AERO ACCESSORIES, LLC SERVICE BULLETIN

SERVICE BULLETIN: SB-011

SUBJECT: Possible Damaged O-Ring

APPLICABILITY: Tempest® Electronic Fluid Pump

Figure 1

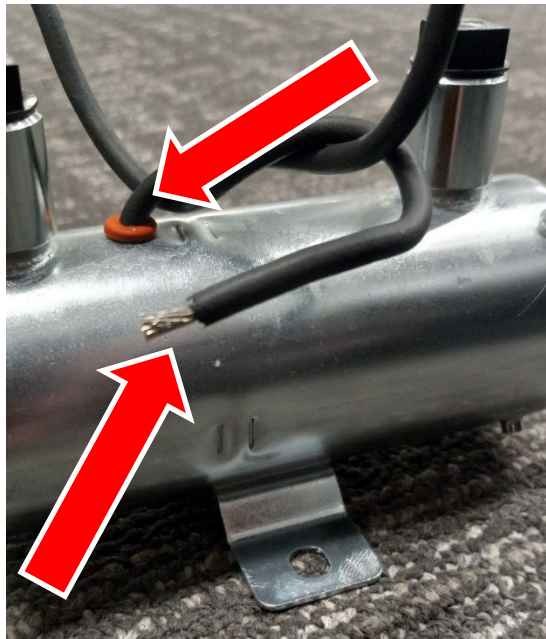
Background: There has been a report from the field of a fluid leak in a Tempest® Electronic Fluid Pump. The area of the leakage was observed at the grommet and, or the end of the lead wire. See Figure 1.

Compliance: When installing a Tempest® Electronic Fluid Pump, operate the pump with fluid. Verify that no fluid is leaking from the fitment points, the end of the lead wire, or around the grommet, See Figure 1. If there is evidence of a leak, do not use the pump, return the pump for an exchange.

Previously Installed Pumps: Tempest® Electronic Pumps that have previously been installed need to be reinspected for leaks within 10 flight hours or 45 days from the effective date of this service bulletin, whichever occurs first. The inspection must be done while the pump is operating and the fluid is present.

If there is evidence of a leak, do not use the pump, return the pump for an exchange.
